Access Compliance Report

Public Rights-of-Way

(Curb Ramps)

Intersection ID: 10037289	Main Street: SARDIS_RD_NORTH	Cross Street: N/A	Location: SE
ADA ID: AAA3E849E229	Ramp Type: Perp	Initial Pass/Fail: Fail	Overall Compliance: No
Severity Score: 12.5			
Codes/Mitigation Info/Possible Solution		Field Measurements/Component Compliance

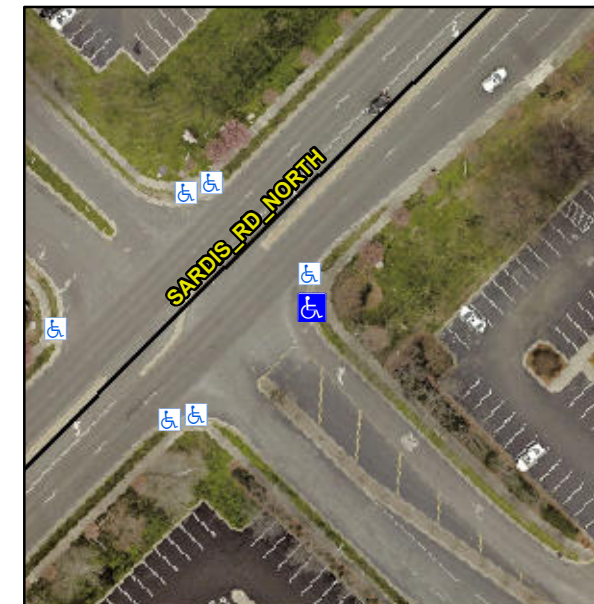
Not Found, R304.2.2

Compliance	Description	Data	Compliance	Description	Data
N/A	Ramp Length (in)	60.0	No	Ramp Slope (%)	8.9
Yes	Ramp Width (in)	48.0	Yes	Ramp XSlope (%)	0.5
N/A	Flare Type LT	N/A	N/A	Flare Type RT	N/A
N/A	Flare Slope LT (%)	N/A	N/A	Flare Slope RT (%)	N/A
N/A	Flare Traversable LT?	N/A	N/A	Flare Traversable RT?	N/A
N/A	Landing Length (in)	N/A	N/A	DWS Provided?	N/A
N/A	Landing Width (in)	N/A	N/A	DWS Contrast?	N/A
N/A	Landing Slope (%)	N/A	N/A	DWS Length (in)	N/A
N/A	Landing X Slope (%)	N/A	N/A	DWS Full Width?	N/A
N/A	Landing Curb? (Y/N)	N/A	N/A	DWS Offset (in)	N/A
N/A	Shared Landing?	N/A			
N/A	Gutter Ponding?	N/A	N/A	Gutter Slope (%)	N/A
N/A	Gutter Lip Ht (in)	N/A	N/A	Gutter X Slope (%)	N/A
N/A	Painted X Walk1?	No	N/A	Painted X Walk2?	N/A
	X Walk 1 Direction	To SW		X Walk 2 Direction	N/A
N/A	X Walk 1 Width (in)	N/A	N/A	X Walk 2 Width (in)	N/A
	X Walk 1 Slope (%)	1.0		X Walk 2 Slope (%)	N/A
	X Walk 1 X Slope (%)	0.4		X Walk 2 X Slope (%)	N/A

Remove & Replace Entire Ramp.
